Application No: BC09/108312
Related Pim Application No: PIM09/108298

Residential/Farm - partial demolition and add bedroom, laundry, WC and kitchen extension to dwelling

AMENDMENT
09-290610

- 1a. Building consent number **BC 09/10 8312**
- 1b. Site address
39 Belt Road
New pLymouth
- 1c. Reason for amendment
☒ Change by owner
☐ Other, please specify
☐ Information request by Council

A2-1

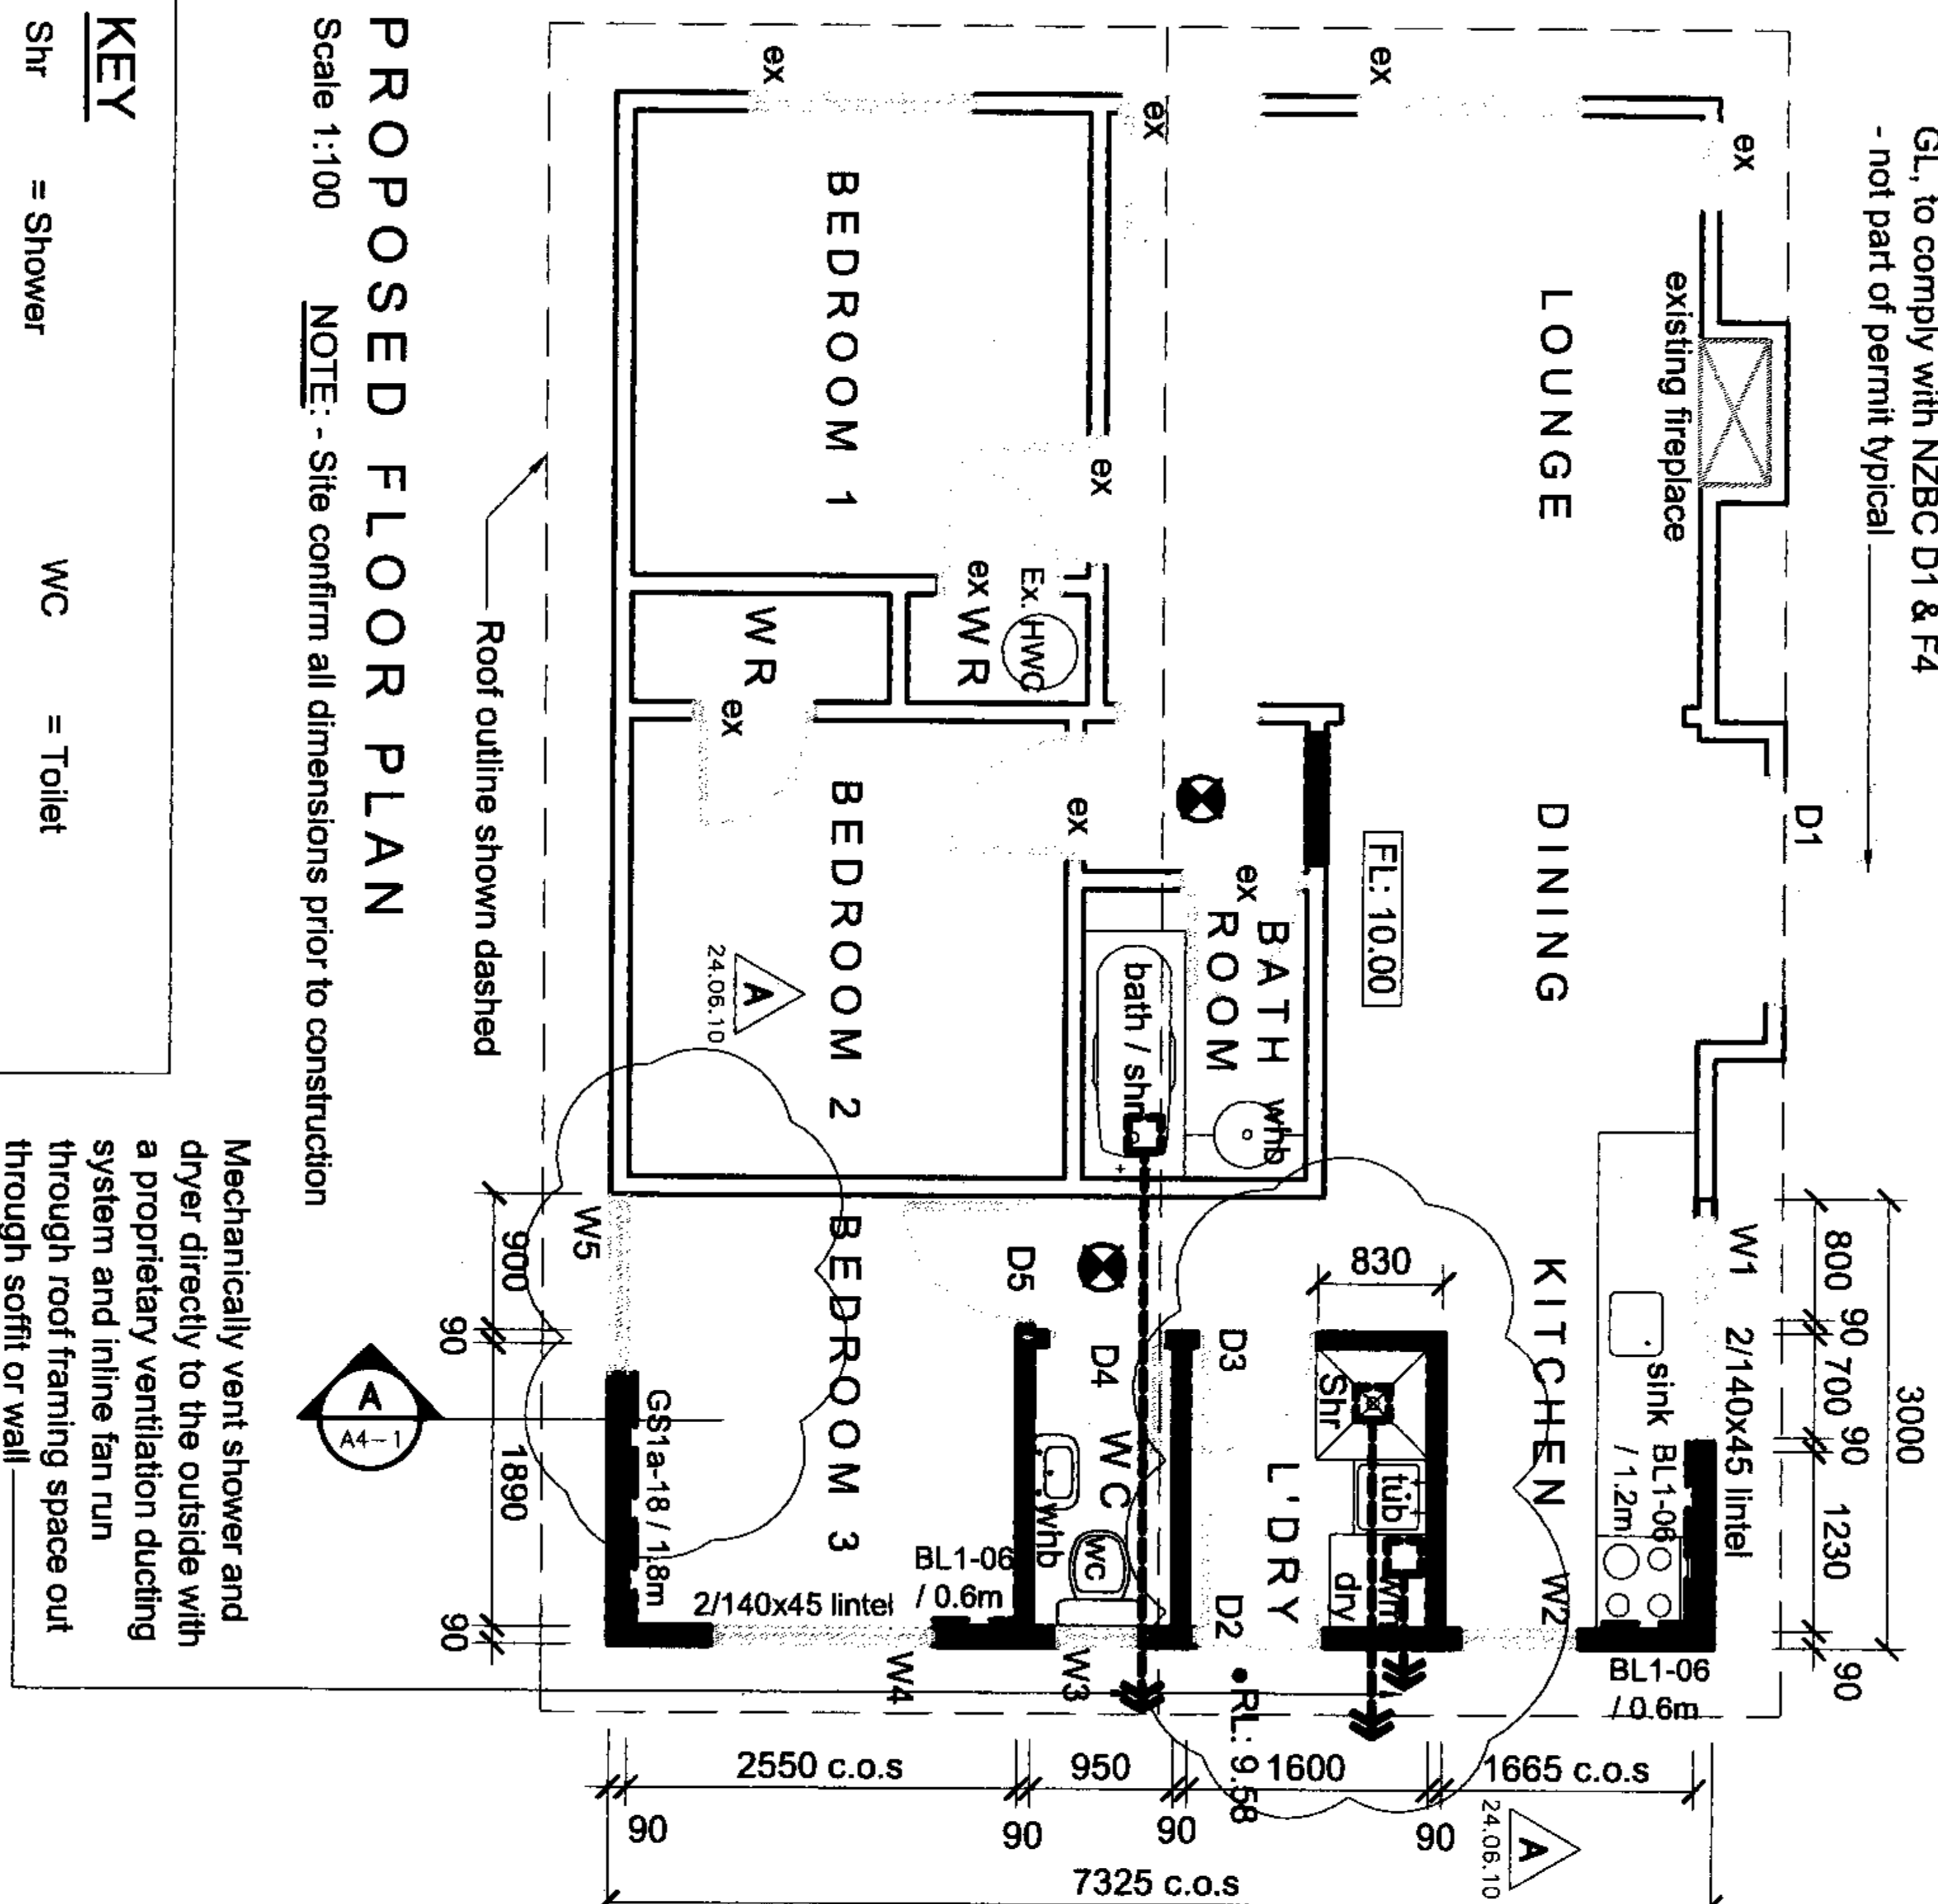
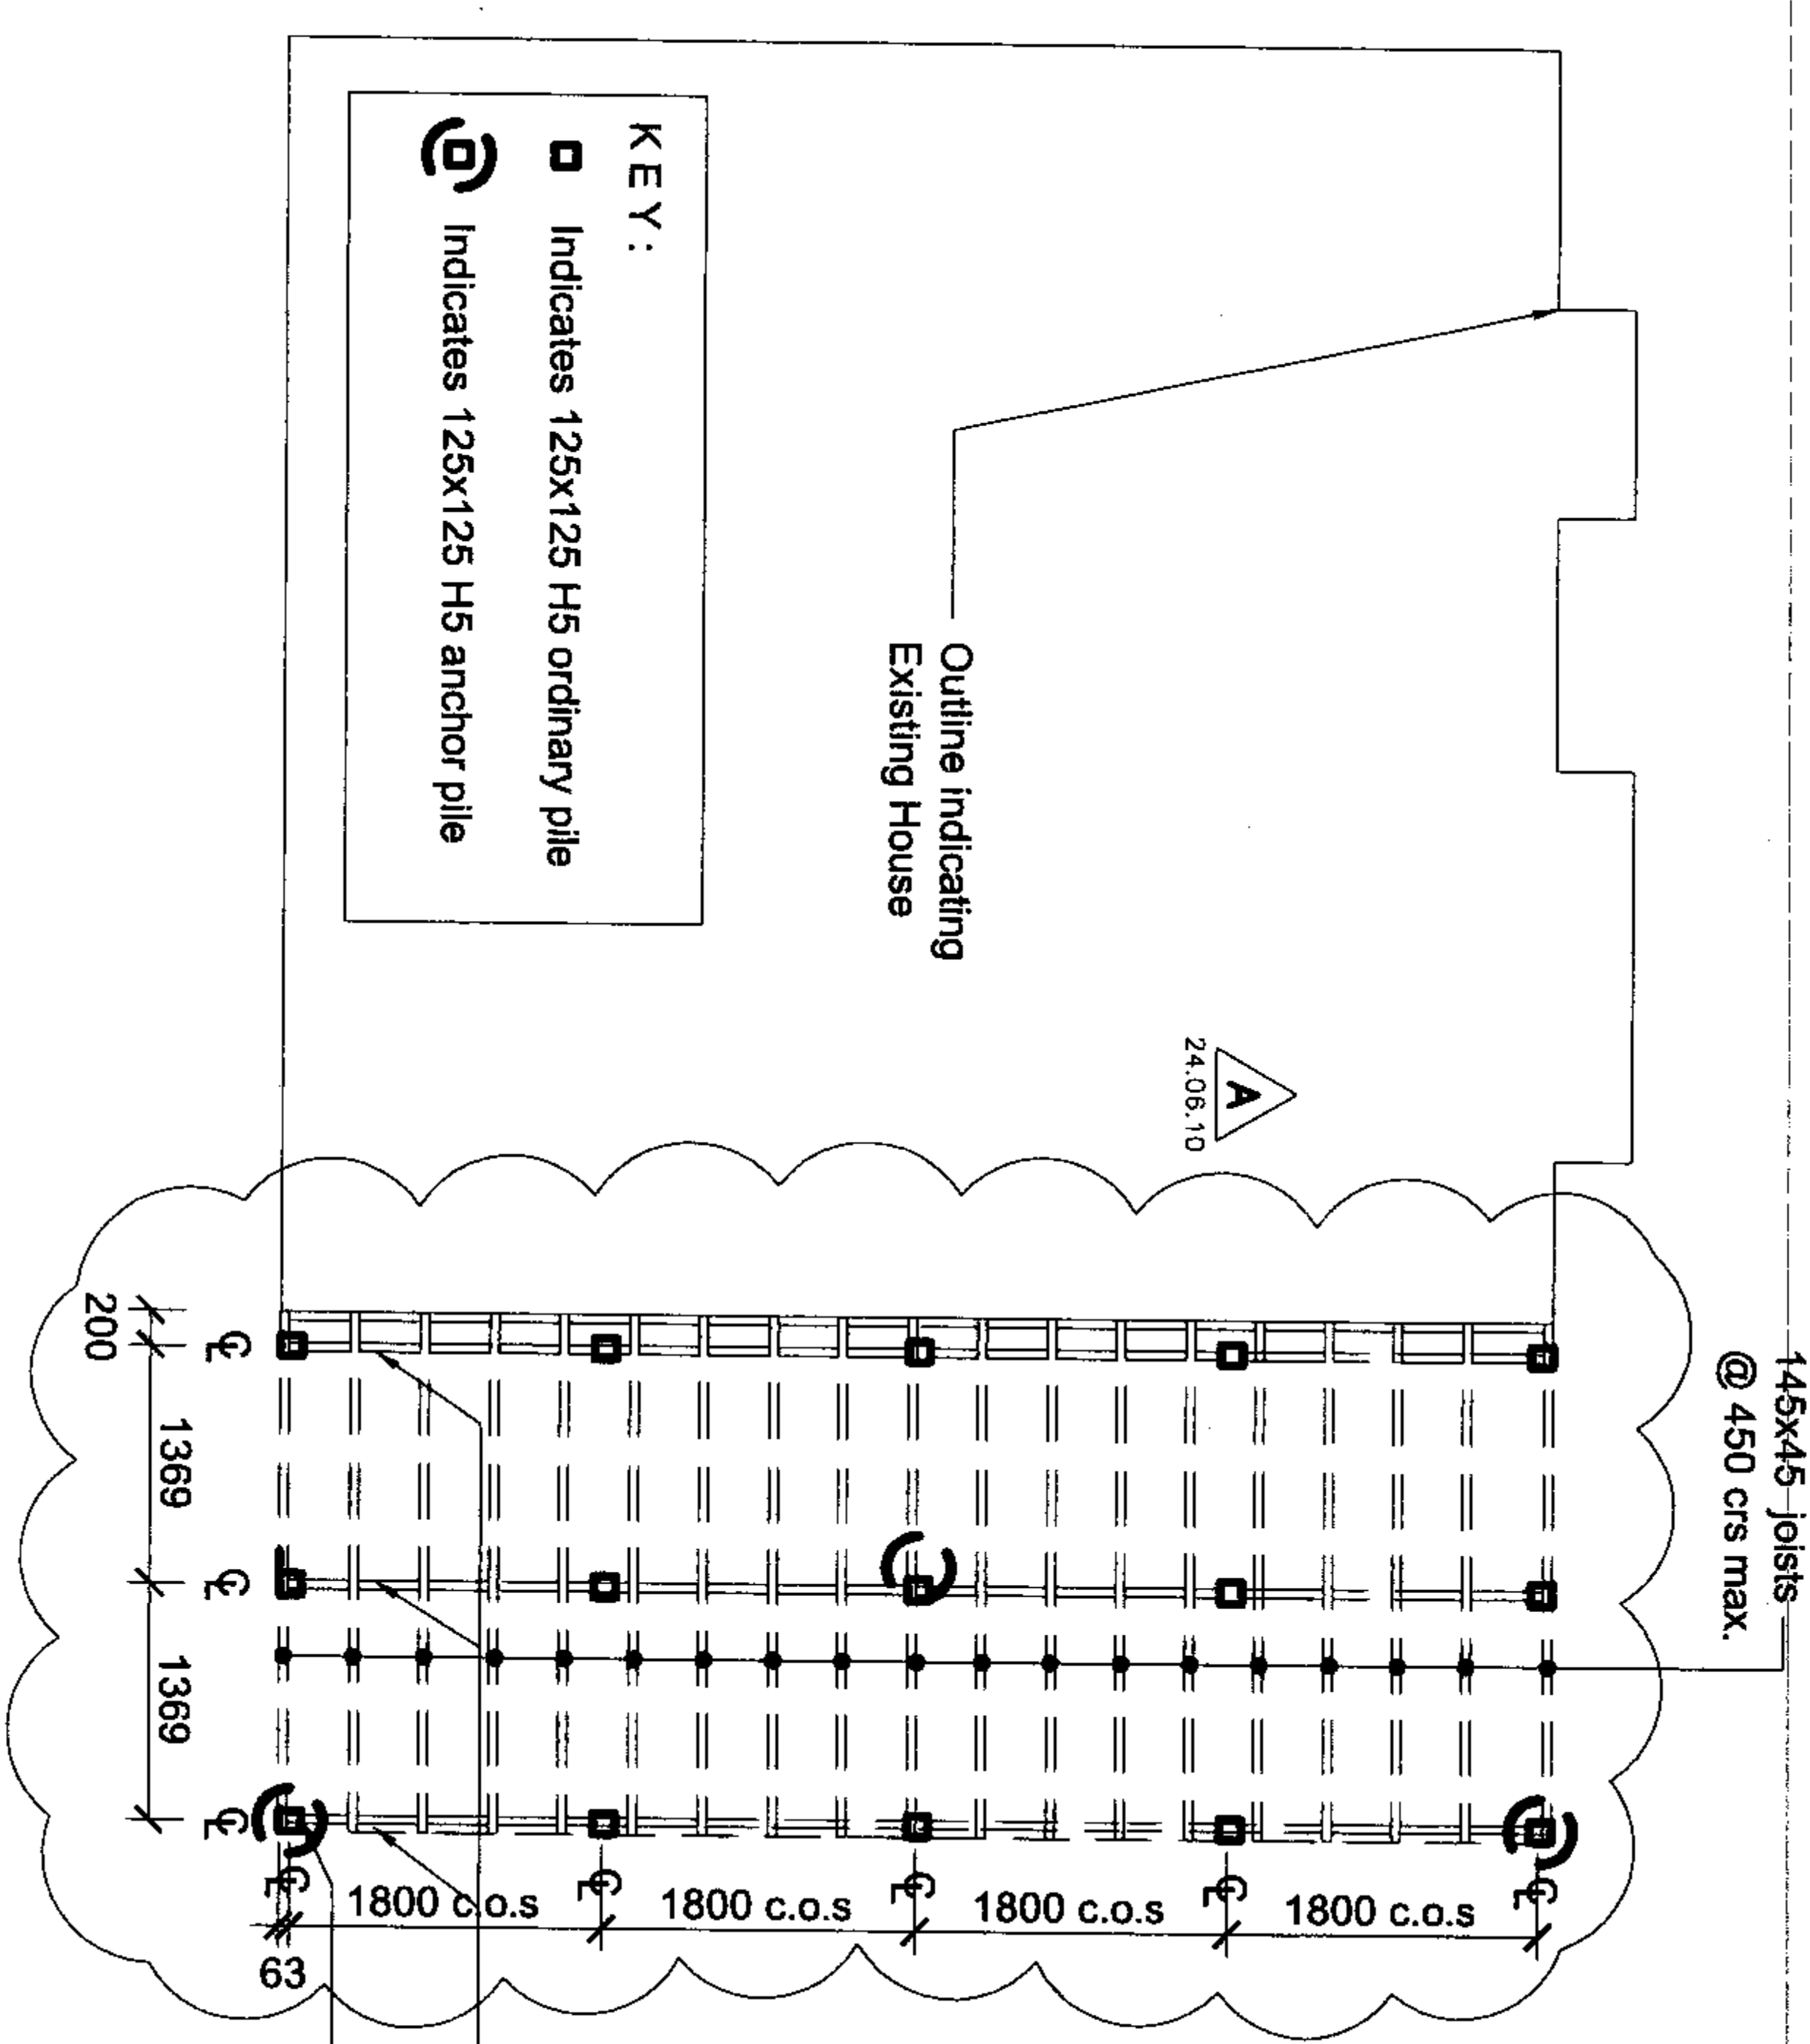
A2-1	A2-1	Shower & W5 added, Plumbing, floor plan, & piles amended

REVISION:	
A	Shower added
	W5 added
	Plumbing amended
	Floor Plan amended
	New row of piles added
	24.06.10
